8-10 New McLean Street

Proponent Response Proposal

Prepared for
DPHI

Issued
July 12 2024

Visual Impact

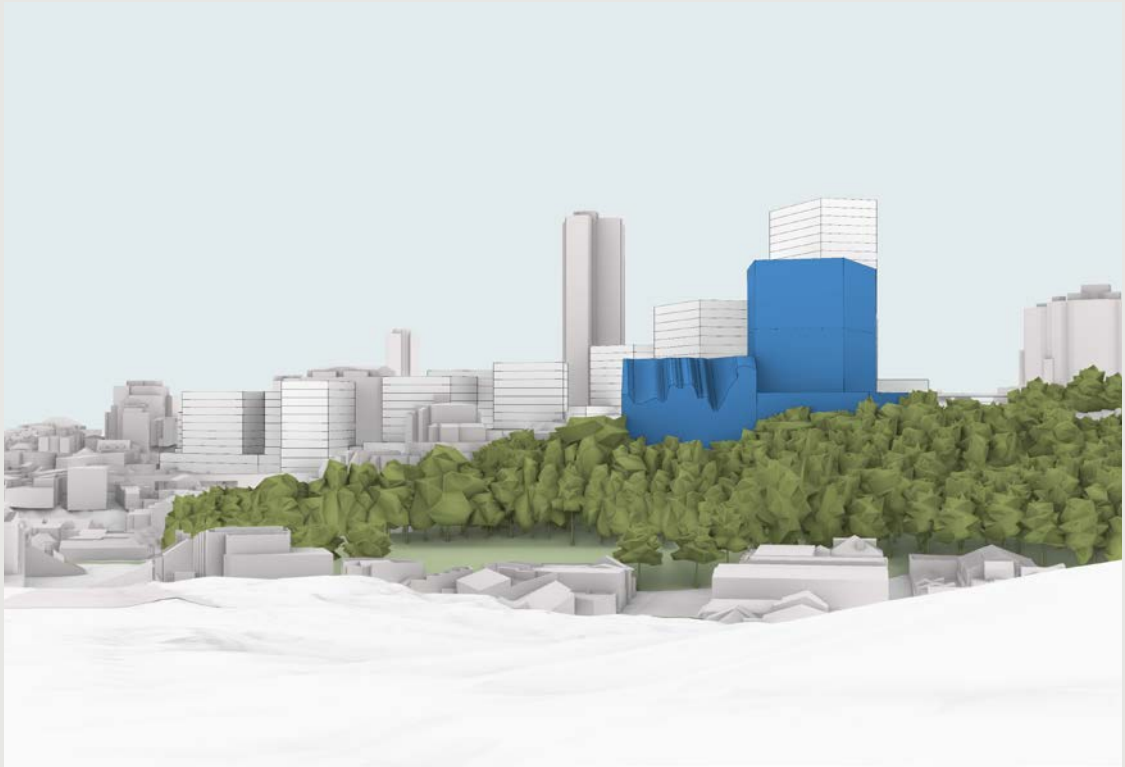
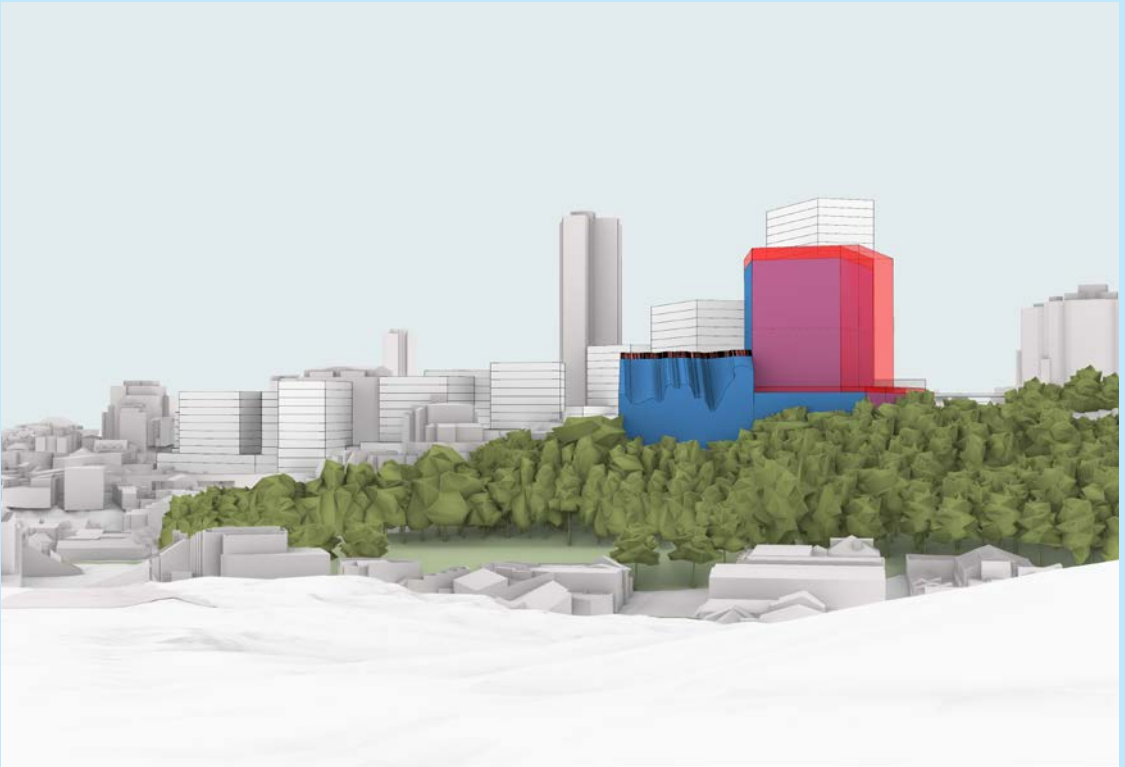
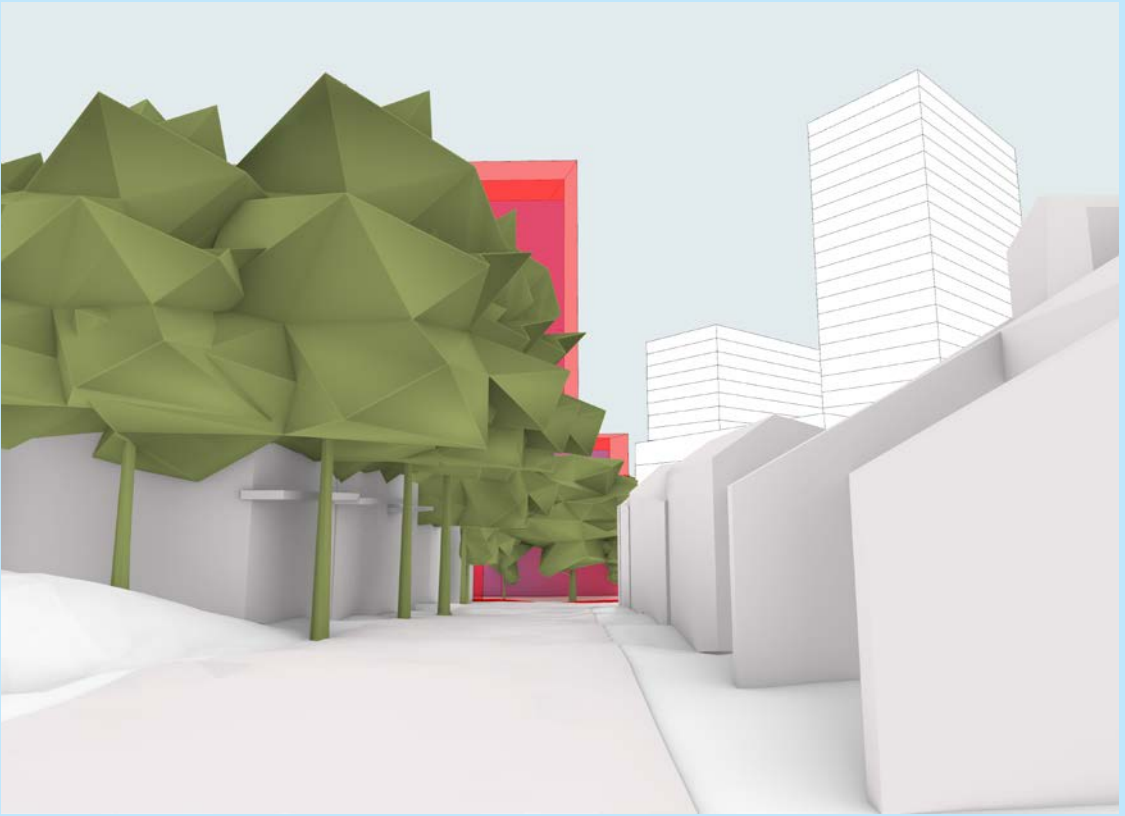
The significant increase in visual impact from the extensions to tower footprint in the Proponent’s responding envelope can be seen in the view from Cascade Street, which would further increase as you travel down Cascade Street towards New South Head Road.

Additionally the envelope’s visibility from Cameron Street is increased further. While largely hidden by existing trees, the increase in tower height can be prominently seen from this view.

Shadow Study

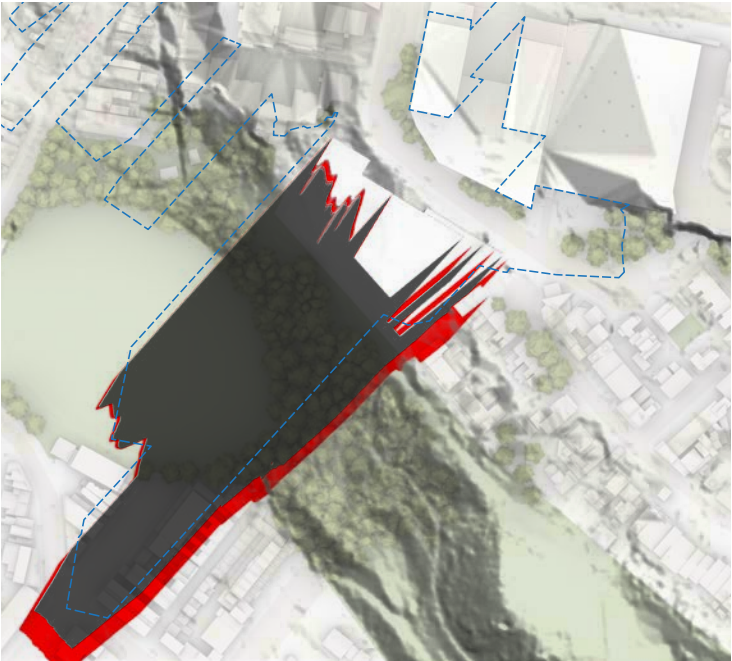
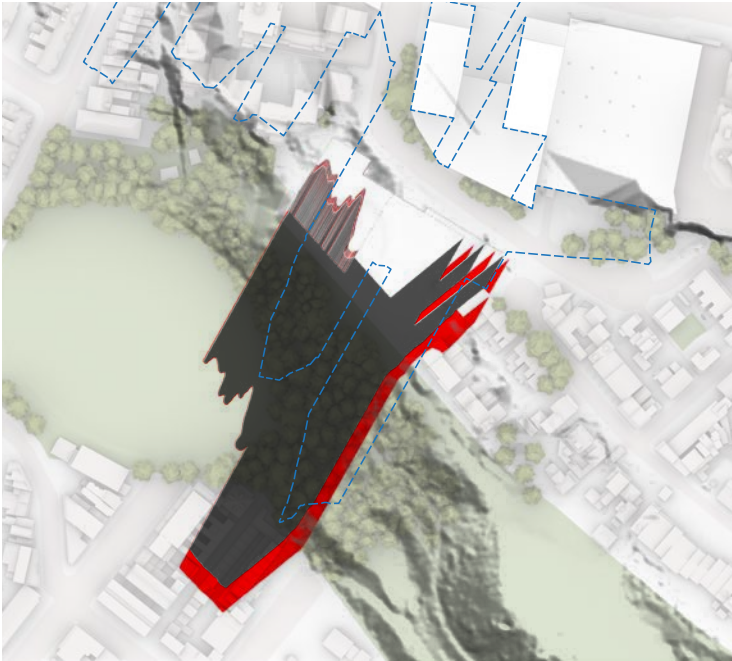
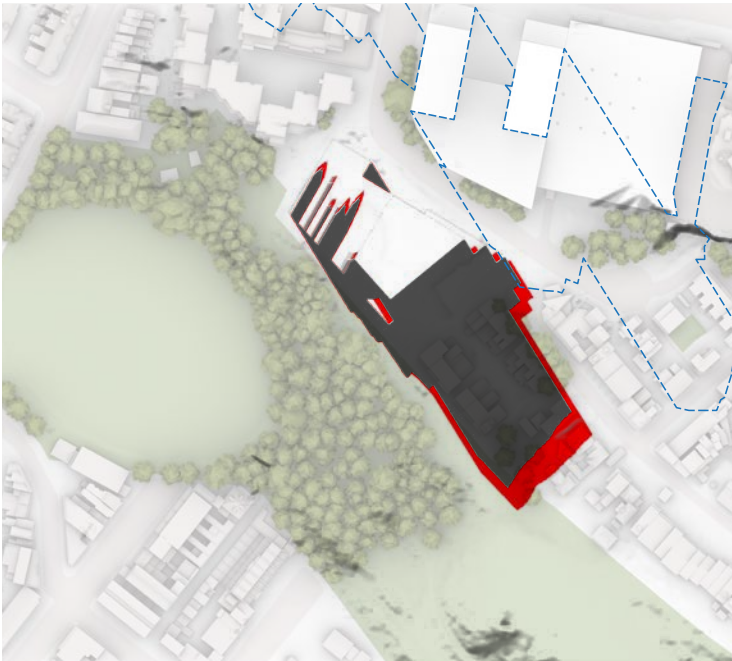
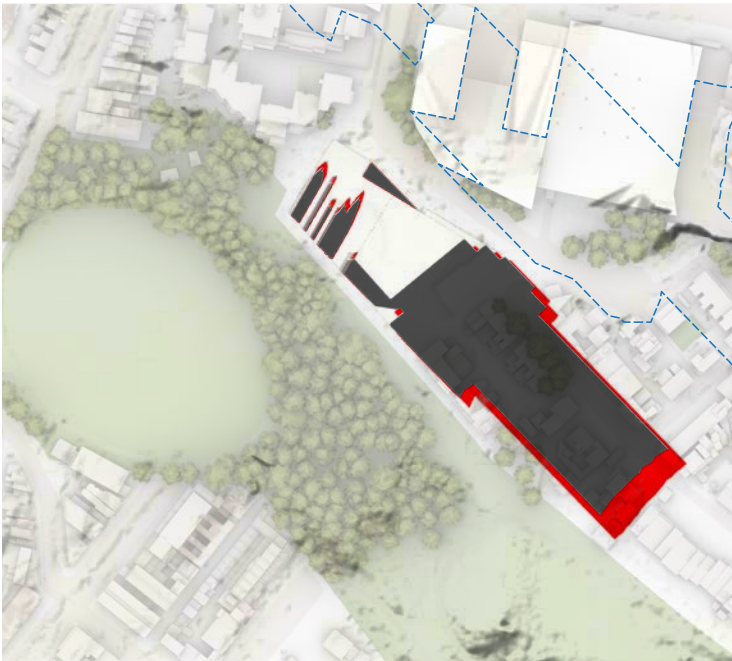
The shadow studies display shadows created on 21 June (Winter Solstice) from 9am to 3pm. The Proponent’s responding envelope shadow impact is shown in red, with the initial SJB envelope shadow is shown in black.

Proposed extensions to the east and south of the tower footprint, along with an increase to overall height shows a significant increase in overshadowing across all times of day.

SJB Final Recommendation Envelope & Controls

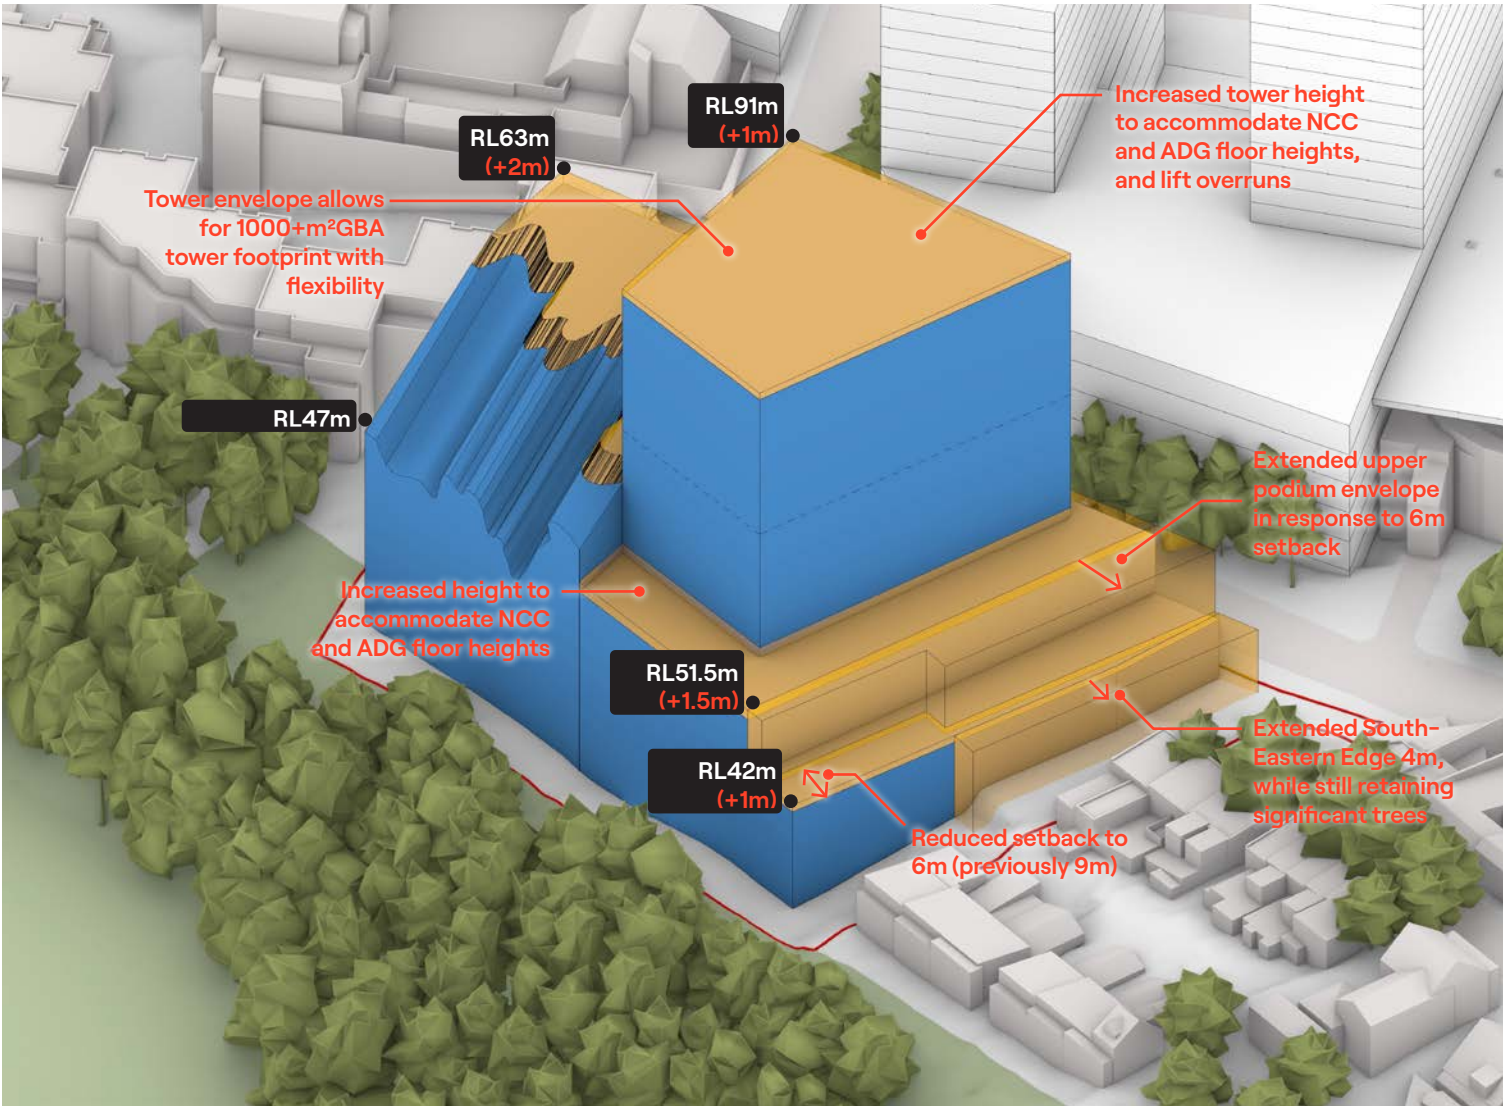
Based on the proposed amendments requested by the Proponent, the assessment of the envelope against the principles, and analysis of visual and overshadowing impacts, an amended envelope recommendation has been made.

- Adjustments to the envelope heights have been made to accommodate NCC and ADG requirements. Increases to podium heights creates minimal to no perceived issues for surrounding areas and is therefore appropriate. The increase to the tower height allows for appropriate lift overruns, but would not permit an additional storey. Access to rooftop spaces would need to be provided within the permissible envelope.
- The flex number of storeys within the flex zone has been increased to accommodate 4 storeys as this would not impact surrounding areas. Height above 4 storeys may impact

- residential amenity within the site and is not encouraged.
- The lower podium has been extended along the south-eastern boundary without impacting significant trees where possible. Further increase would likely impact trees and is not encouraged.
 - Upper podium setbacks have been extended by 3m to the south-eastern boundary, as the extension maintains an appropriate transition in heights to the surrounding context. This change does not cause an impact to surrounding areas and is therefore considered appropriate.
 - The tower envelope's footprint has not been extended, as the envelope is already capable of fitting a tower footprint of 1,000m² GBA. Anything beyond this would be too bulky and cause visual and overshadowing impacts.

Shadow Study

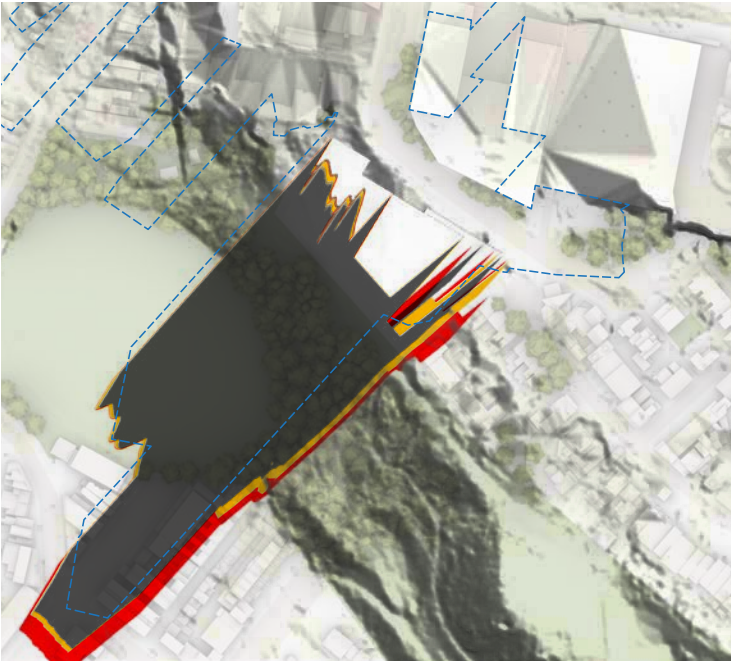
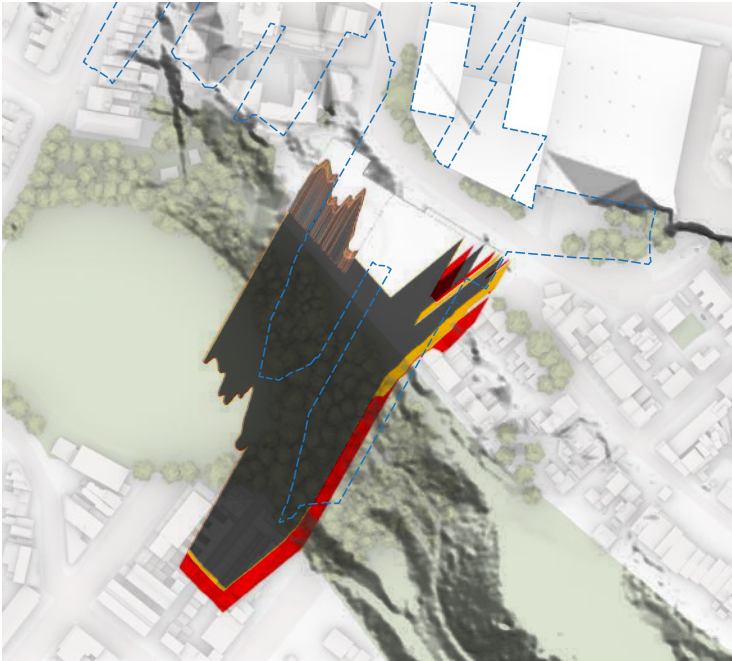
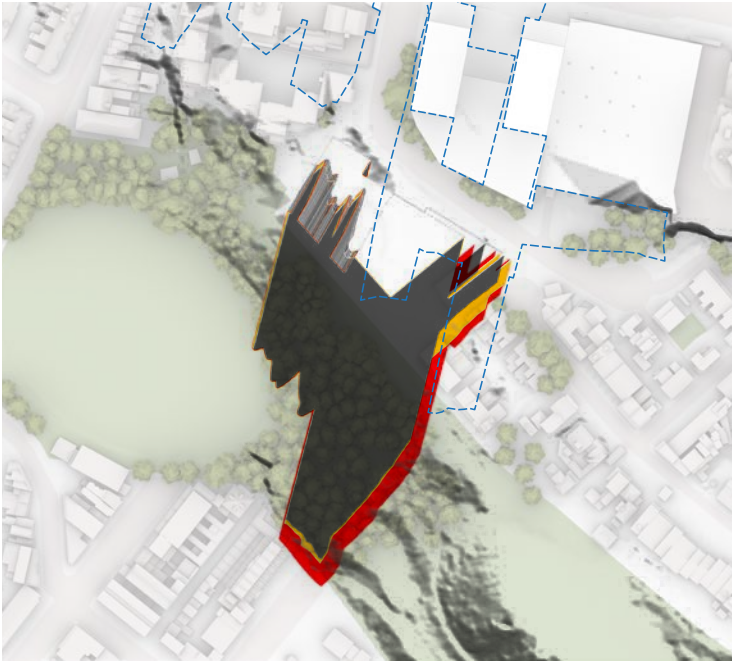
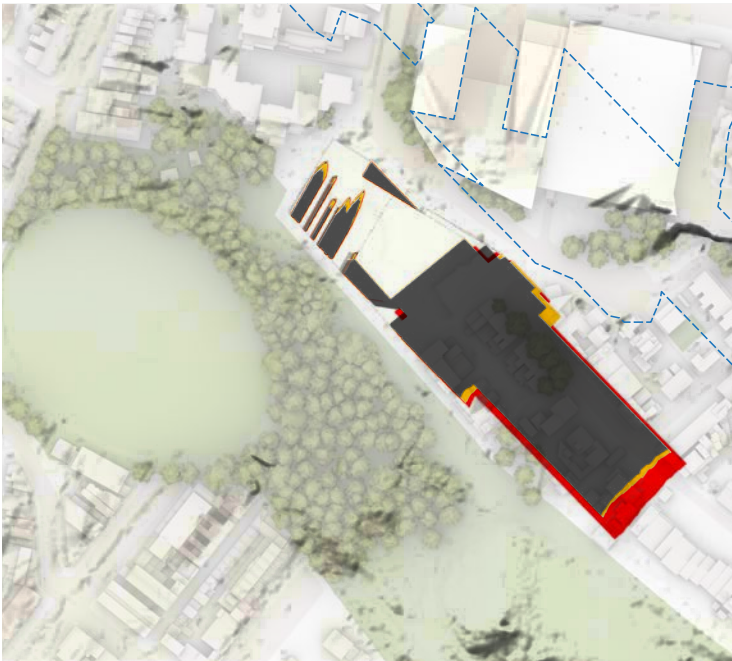
The shadow study shows the difference in overshadowing impact when the initial tower envelope is maintained, where increases to the shadow of the final recommendation are only present in the lower podium levels and provide lower impact than the Proponent response.

At 9am the proposed shadow extent sits almost entirely within the shadow extent of the ECC proposed. At 10am, there a small impact to properties across Trumper Park, however these properties will receive adequate sunlight for the remainder of the day. From 12pm, private open spaces of the terraces in the adjacent properties are being impacted slightly by the proposed, however they are also being impacted by the proposed ECC massing and will still receive adequate sunlight throughout the day of greater than 3 hours total.
